6571A-09

**S E R V I C E N O T E**

**6571A DC POWER SUPPLY, 0-8 V, 0-220 A, 1760 W.  
MANUALLY CONTROLLED.**

**Figure 3** Regal Non locking Nut

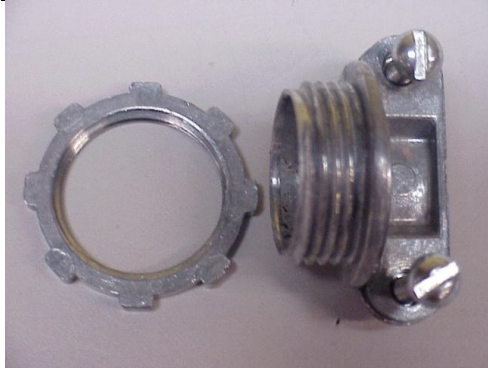
Figure 2 shows the inside of the AC Safety Cover housing the incorrect hardware is shown. It will be very difficult to tighten the strain relief. AMC (Asian Manufacturing Center) uses a special tool to tighten the locking nut. When the incorrect nut is used or a locking Nut is put on incorrectly the strain relief will become loose as described above.

Figures 3 & 5 is representative of a not without locking ribs.

The entire AC **INPUT SAFETY COVER** P/N 5040-1676 should be replaced.
